MEMORANDUM

SUBJECT: Site Plan Approval – 514, 528 and 540 State Street

DATE: December 29, 2022

Request: Site Plan Approval for the construction of a 2,738 sq. ft. Taco Bell restaurant and associated site improvements at 514, 528 and 540 State Street, Parcel Numbers 12-03-126.000, 12-03-127.000 and 12-03-128.000

Site Plan

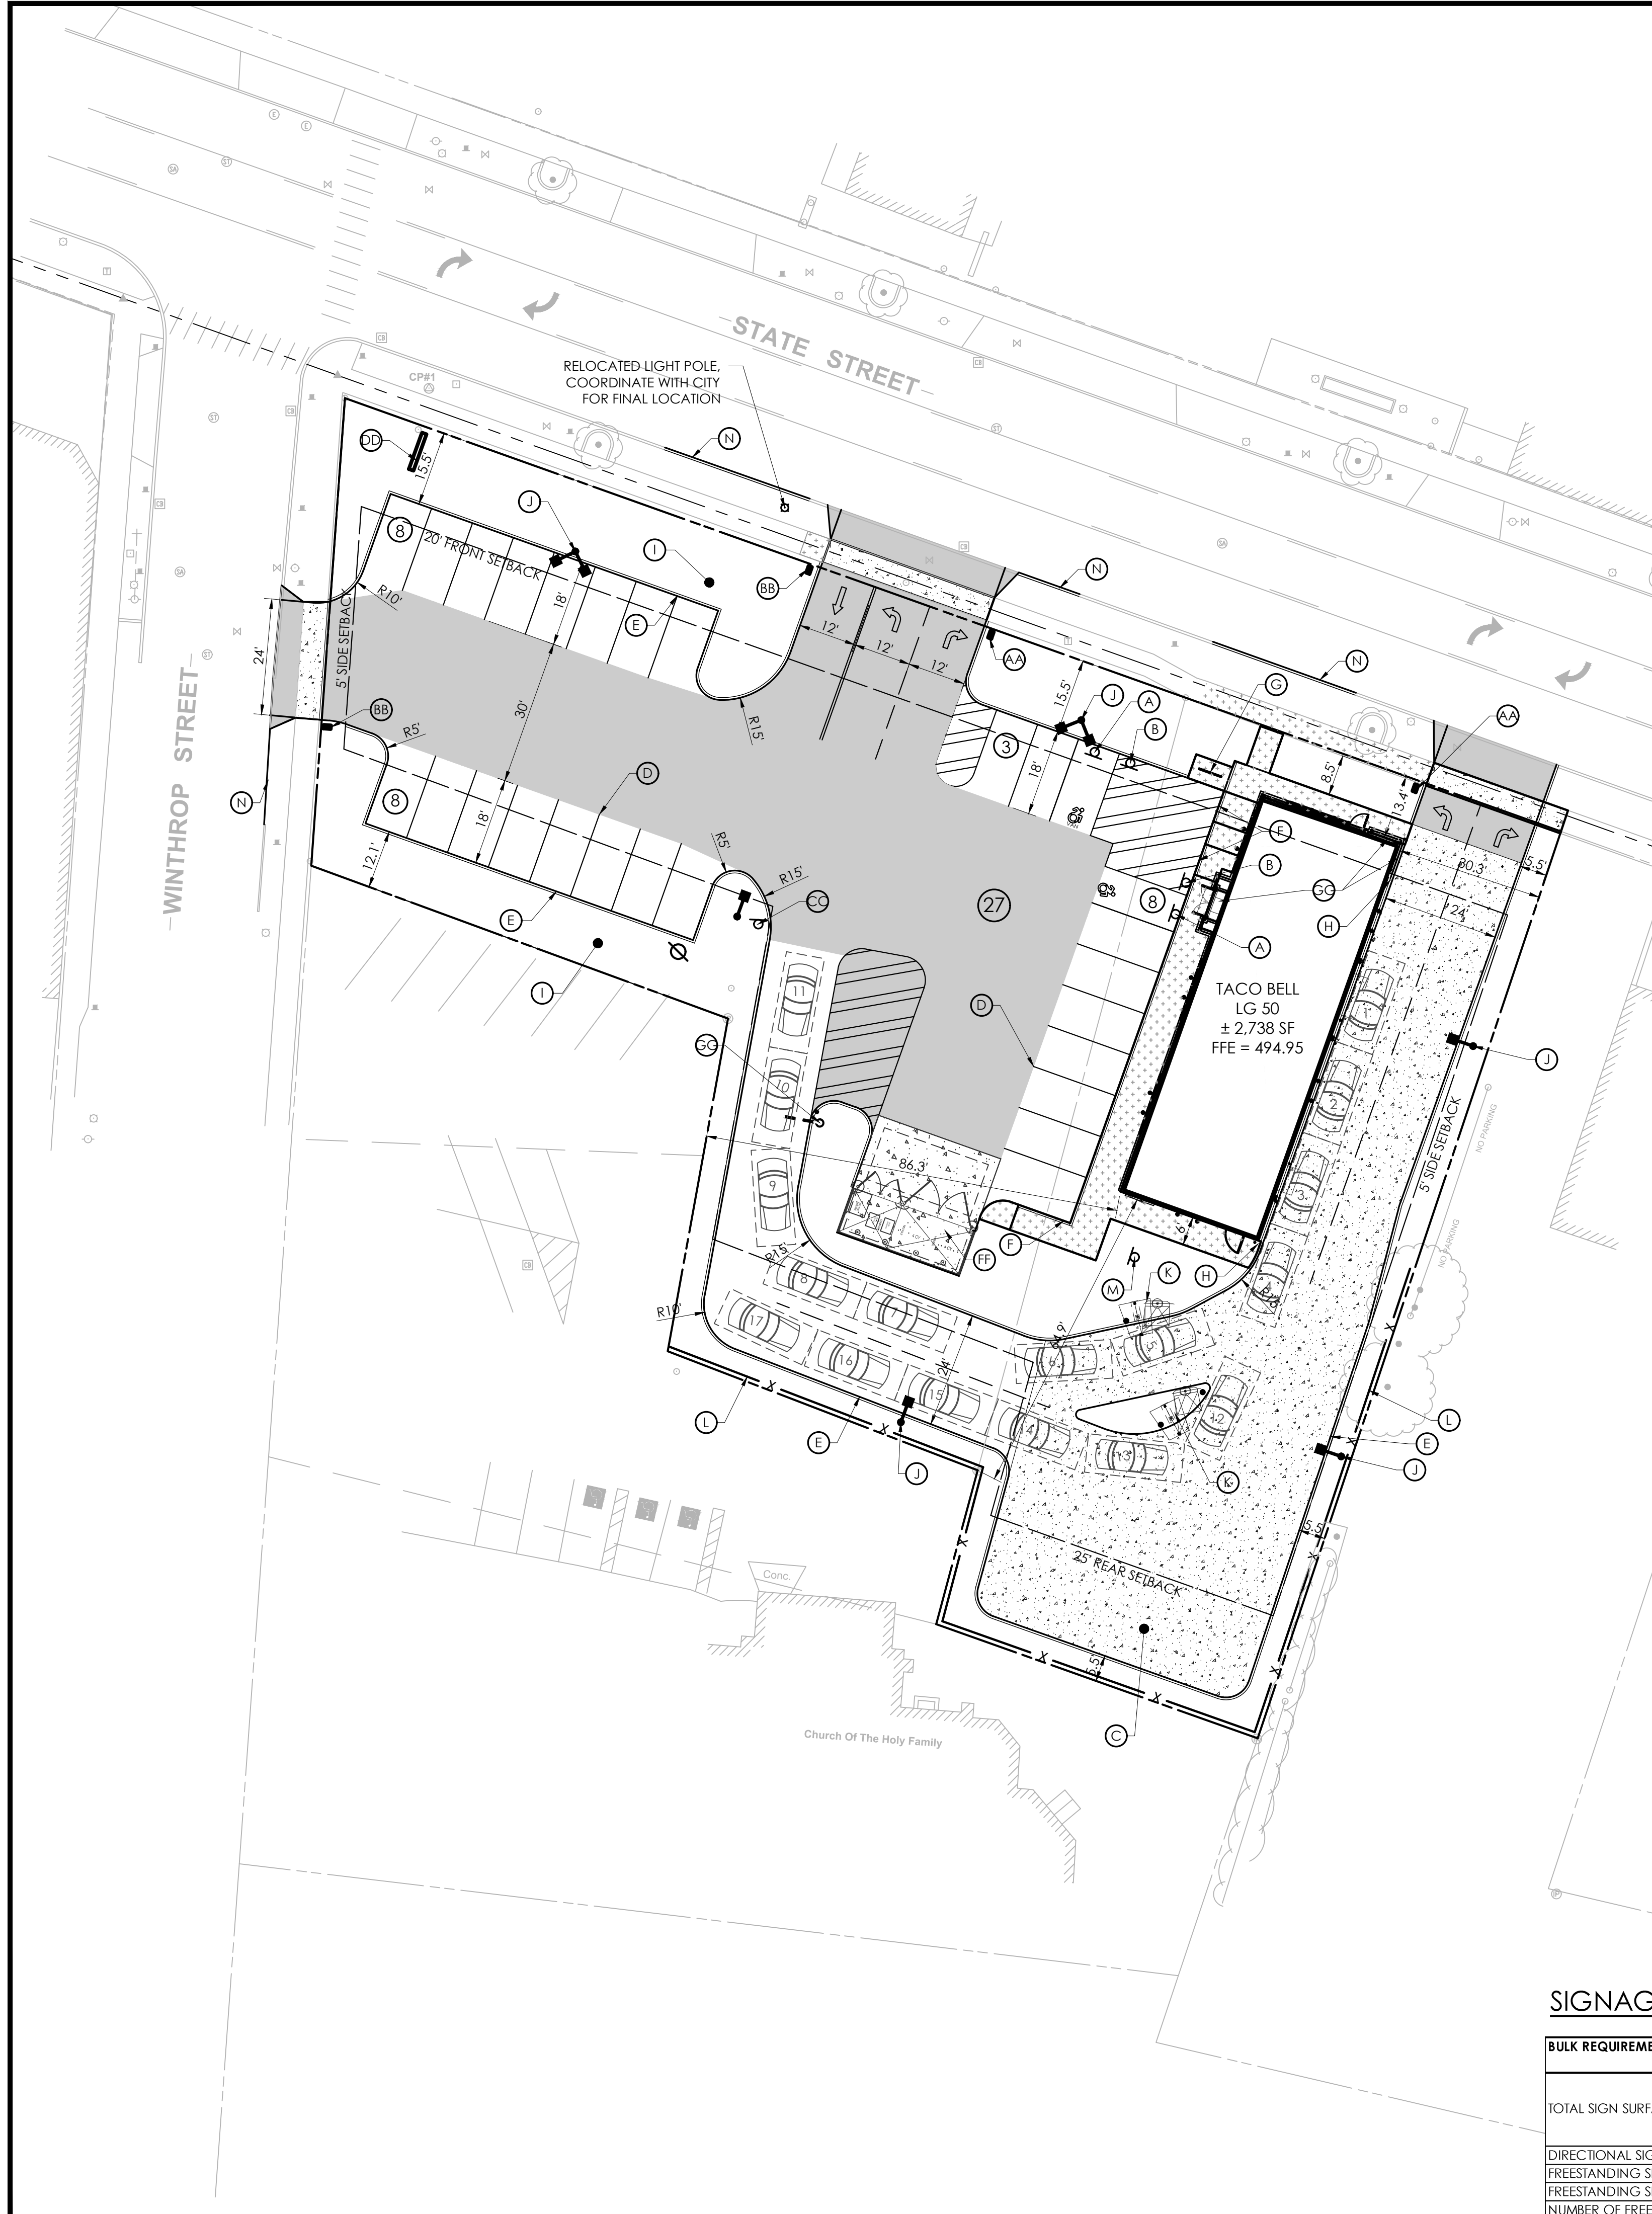
Setbacks: The Commercial District requires that the building is setback a minimum of 20 feet from the front parcel line. The submitted site plan shows the proposed building setback to be 13.4 feet. The applicant applied to the Zoning Board of Appeals for an Area Variance to request relief from the required 20-foot front building setback. The Zoning Board of Appeals approved the request at the December 21, 2022 to allow for the 13.4-foot front building setback. All other required setbacks have been met.

The submitted site plan shows the required five-foot landscape buffers on the sides and rear of the site. However, a portion of the front landscape buffer is only 8.5 due to the reduced building setback. The applicant applied to the Zoning Board of Appeals for an Area Variance to request relief from the required 15-foot front landscape buffer and reduce it to 8.5 feet. The variance application was approved by the Zoning Board of Appeals on December 21, 2022.

Other: As required in the site plan application, the applicant has shown a proposed concrete snow storage area on the site, located at the southern most section of the property, below the drive-thru order points. The size of the concrete snow storage area is somewhat excessive, measuring approximately 30’ x 60’. The applicant should reduce the size of the snow storage area by 10’ on the west, south and east sides to provide a larger landscaped buffer more suitable for the long-term survival of the plant material placed there and to reduce the amount of impervious area on the site.

6. The applicant must coordinate with and obtain permission from National Grid for the proposed street light relocation.
7. The applicant should reduce the size of the snow storage area by 10' on the west, south and east sides to provide a larger landscaped buffer more suitable for the long-term survival of the plant material placed there and to reduce the amount of impervious area on the site.

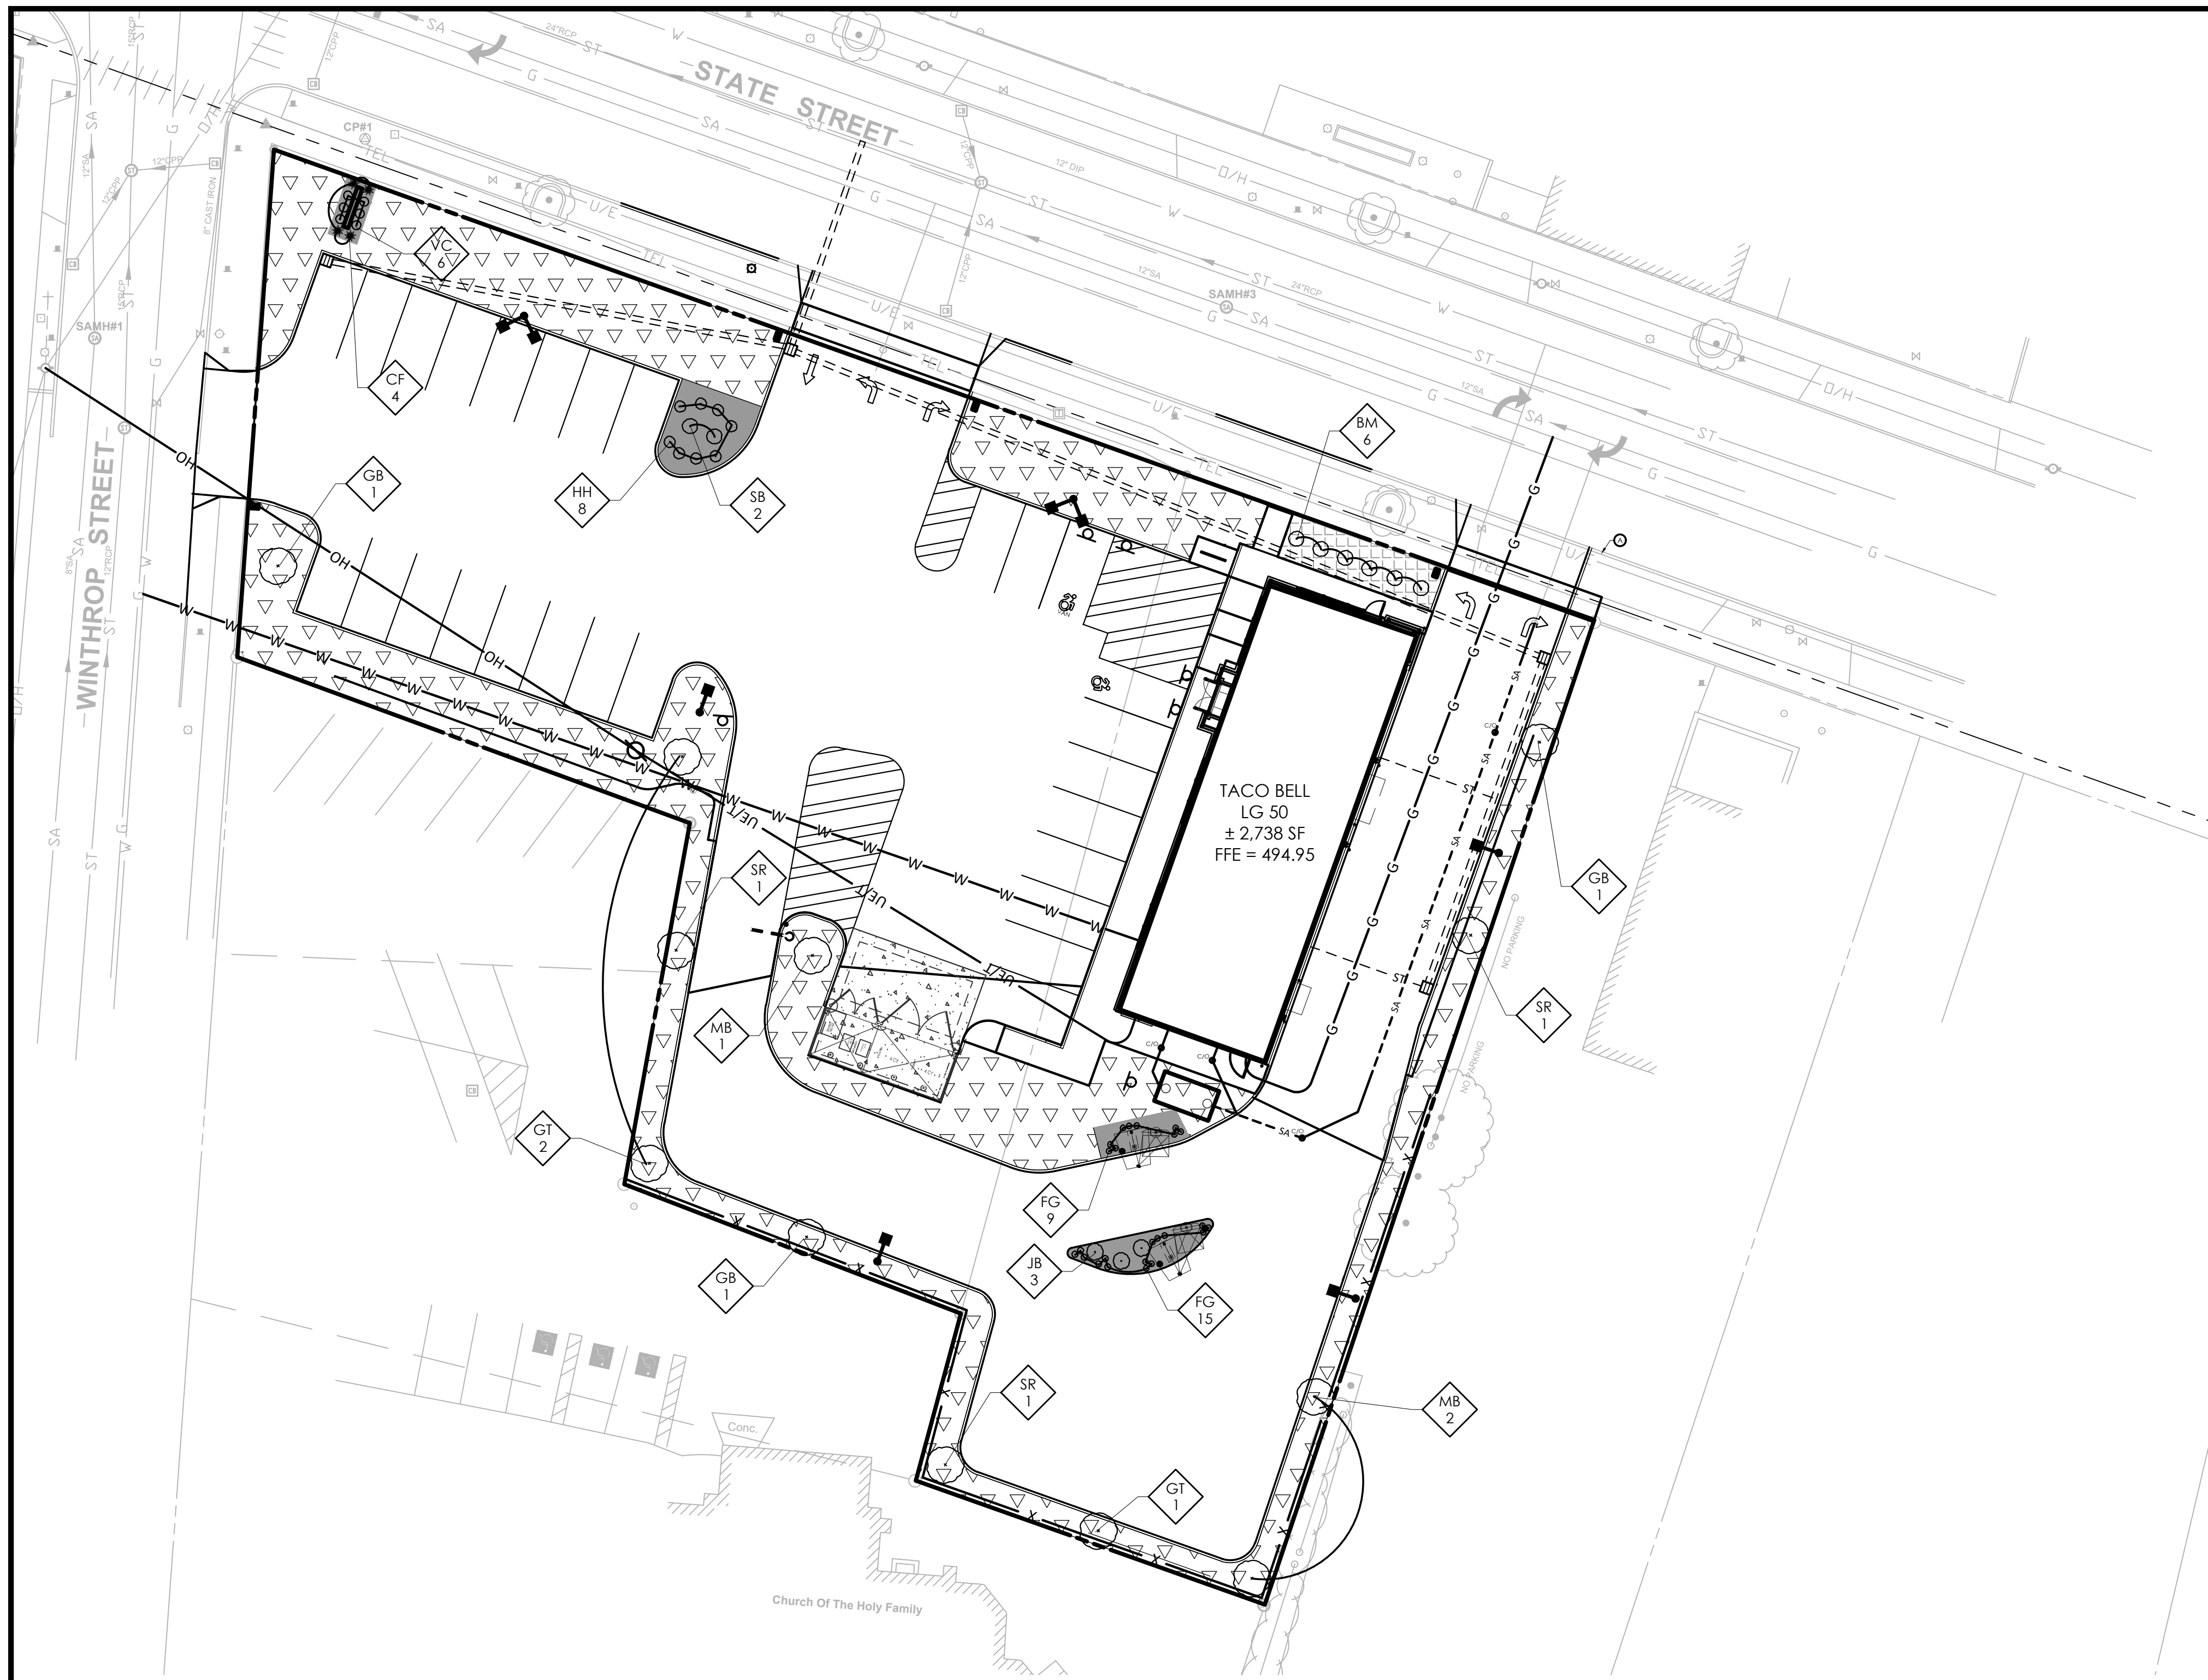
While the width of the buffer along the southern side of the site understandably varies due to various site layout needs, the composition of the buffer is lacking. No trees or shrubs are shown along the parking spaces. They must, however, be provided. Along the drive thru lanes, no shrubs are proposed, and only a few trees have been provided but not at the recommended spacing or correct tree type. The applicant shall revise the landscaping plan to include one large deciduous tree planted every 40' or one small to medium deciduous tree planted every 20' or one large coniferous tree planted every 20' along the southern site boundary to adequately buffer the residentially zoned areas.

In order to plant the required trees in the landscaped areas, it may require relocation/shifting of the water and storm sewer lines. The water line can be easily shifted/rotated to the north to provide space for trees along the parking spaces and the catch basins can be shifted slightly to push the alignment of the storm sewer main away from the center of the planting areas.

4. The applicant shall revise the landscaping plan to include one large deciduous tree planted every 40' or one small to medium deciduous tree planted every twenty feet with planting beds in between the trees in the areas along the street rights-of-way.

5. The applicant shall revise the landscaping plan to include one large deciduous tree planted every 40' or one small to medium deciduous tree planted every 20' or one large coniferous tree planted every 20' along the eastern property line and along the southern site boundary to adequately buffer the residentially zoned areas
